# ADA Curb Ramp New Construction Inspection Form (Parallel)

NW Timeric

23885.56

NW Lenux

PARALLEL RAMP (PL)

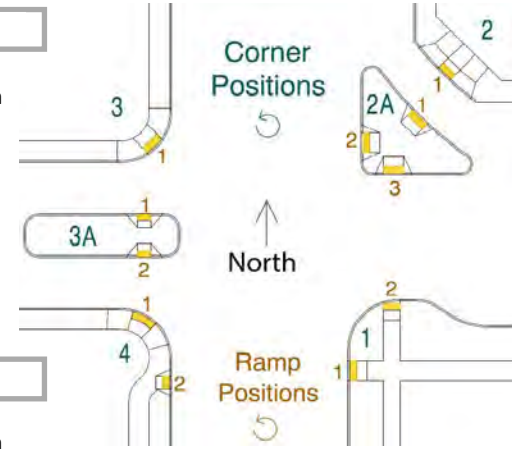
☐ **11.5**  $\leq 8.3\%$  ☐  $> 8.3\%$  ☒

**11.3**  $\leq |5.0\%|$  ☐  $> |5.0\%|$  ☒

**7.3**  $\leq 2.0\%$  ☐  $> 2.0\%$  ☒

**7.1**  $\leq 2.0\%$  ☐  $> 2.0\%$  ☒

**3.5**  $\geq 4.0'$  ☐  $< 4.0'$  ☒

NTD Fails RR 1 and Turn space
